ATTACHMENT B - AGENCY APPROVAL LETTERS

Re: **SITE DEVELOPMENT STORMWATER
MANAGEMENT PLAN** Request for ELP
Bethesda at Rock Spring
Project Phase: Phase 2
Site Plan No. 820240130
Preliminary Plan #: 120210040
SM File #: 286375
Tract Size/Zone: 33.6 Acres/CRF-1.5
Total Concept Area: 440,968 sf/10.12 Ac.
Parcel(s): N737
Watershed: Cabin John Creek/Class I
Redevelopment: Yes

Re: ELP Bethesda at Rock Spring Phase 2
Site Plan # 820240130

DATE: 26-Sep-24
TO: Keely Laretti
Soltész, Inc
FROM: Marie LaBaw
RE: ELP Bethesda Phase 2
820240130 (see 120210040 820210190 820220120)

FIRE LANE SIGN PLAN
ELP BETHESDA AT ROCK SPRING PH.2
 7TH ELECTION DISTRICT
 MONTGOMERY COUNTY, MARYLAND

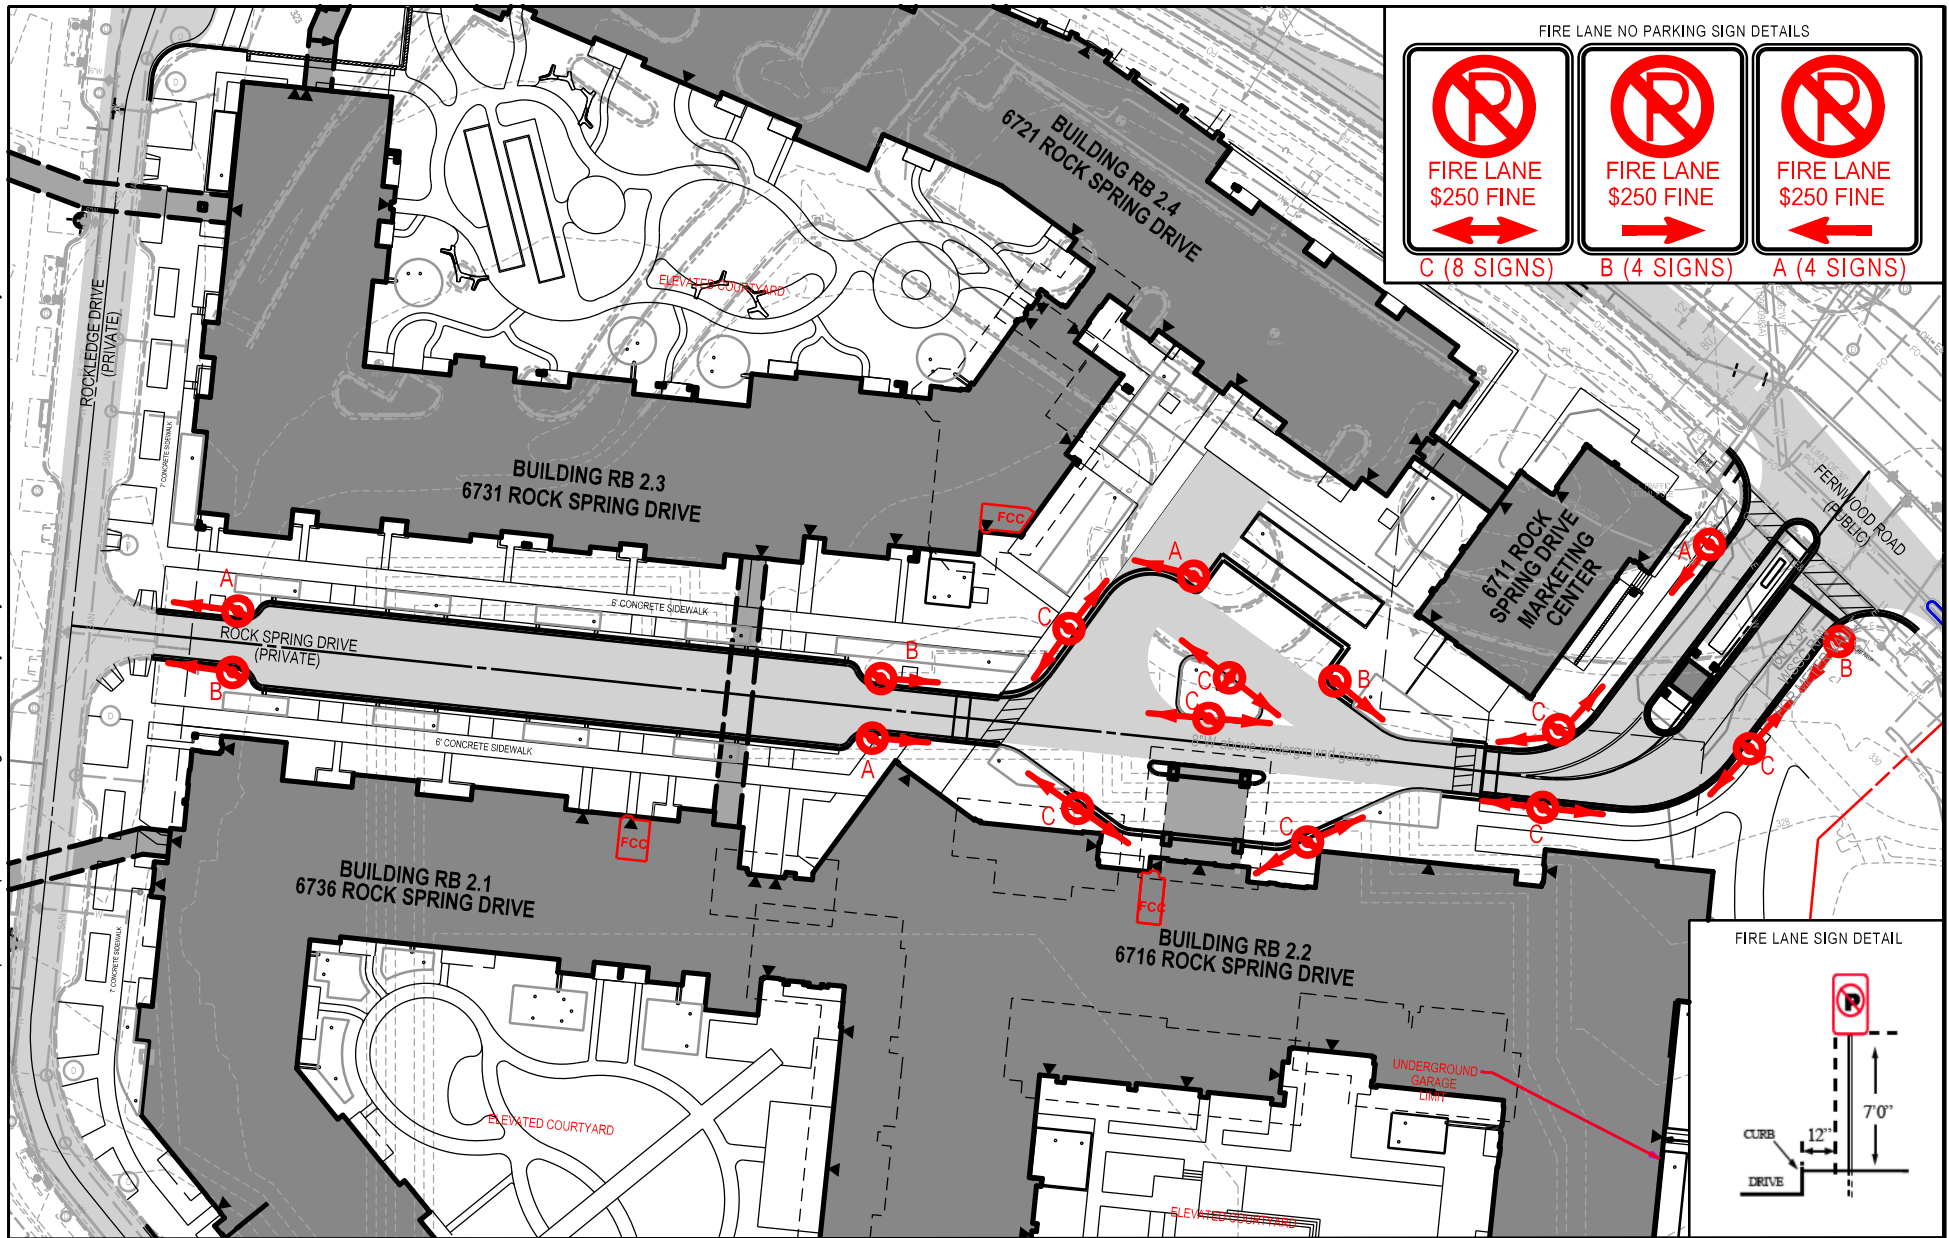
- SIGNS** -- (See attached diagram for location of sign placement)

Signs must be posted so that it is not possible to park a vehicle without being in sight of a sign. Signs may be no further apart than 100 feet.

- PAINT** -- (See attached diagram when painting is required)

Paint must be traffic yellow with lines of sufficient width to be readily identifiable/readable by motor vehicle operators.

Project Name
ELP BETHESDA AT ROCK SPRING PHASE 2
Project Number
0693-04-00
Date
9/26/2024
Scale
1" = 60'
FIRE ACCESS PLAN
Drawing

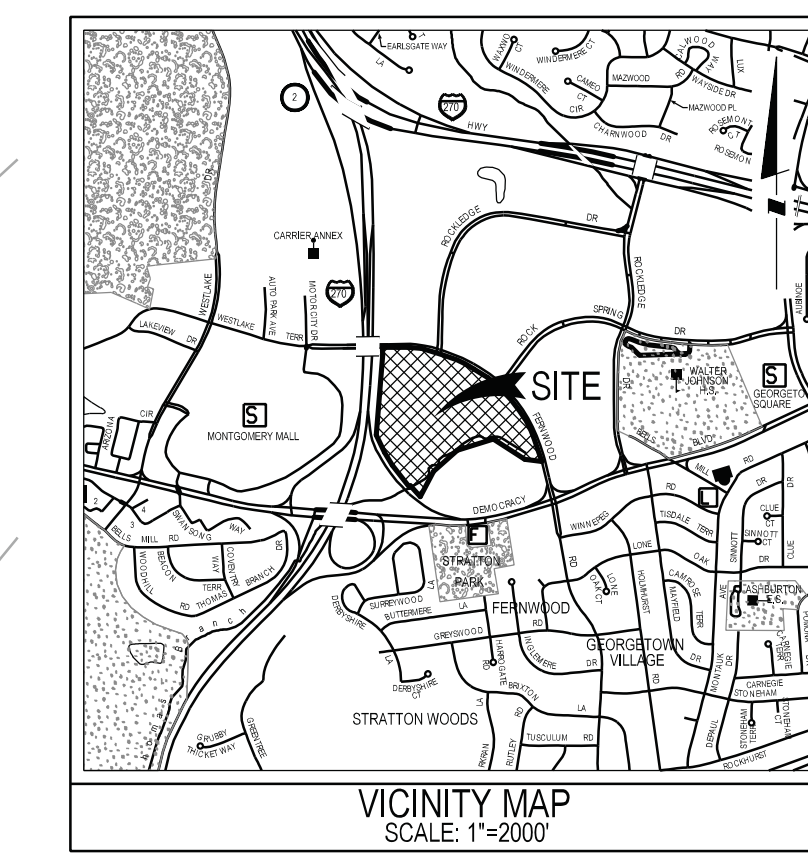
On behalf of our client, ELP Bethesda c/o Erickson Living Management LLC, we are requesting the review and approval of a site plan performance-based design in conjunction with a proposed assisted living development on the property described below. Previously a preliminary plan fire access review was done for this property and layout.

As discussed and approved during the Preliminary Plan review of project #120210140, both Rock Spring Drive (previously Central Internal Drive) and the plaza to access the front door of Building RB 2.4 will meet the loading requirements of Admin interpretation 09-01 to support aerial operations for punching shear loads. Concrete paving, mountable curb, and asphalt paving will be designed to meet this requirement. The plaza space is bordered by planters and parking to designate fire access across the plaza to the front door of building RB 2.1. Since the plaza and drive provides access and support for 20 x 50' fire department paving for trucks and outriggers to 50' from the front doors of Buildings RB 2.1, RB 2.2, RB 2.3, RB 2.4 and the marketing center, as well as providing additional fire access along Fernwood Drive, Rock Spring Drive private, and fire department vehicular access, we believe that the performance based design in this case will provide adequate access for fire apparatus to these buildings. The concrete paving and curb will meet apparatus loading to be no less than 85,000 lbs at grade.

Finally, along Fernwood Road as previously approved, secondary fire access is being provided with operational bays spaced along the road to provide 20' x 50' of paving for fire department trucks and outriggers to set up in front of the center, mountable curb and concrete paving is proposed to expand the 16' drive to 20' wide. The concrete paving and curb will meet apparatus loading to be no less than 85,000 lbs at grade.

PLAN APPROVED

FIRE CODE ENFORCEMENT
Fire Department Access Review
Review based only upon information contained on this plan. Does not cover unsatisfactory layout resulting from omissions, errors or failure to clearly indicate conditions on this plan. Correction of such unsatisfactory layout to afford required access will be required if found upon inspection after installation.
BY: SAC PM: 43 DATE: 9/26/2024
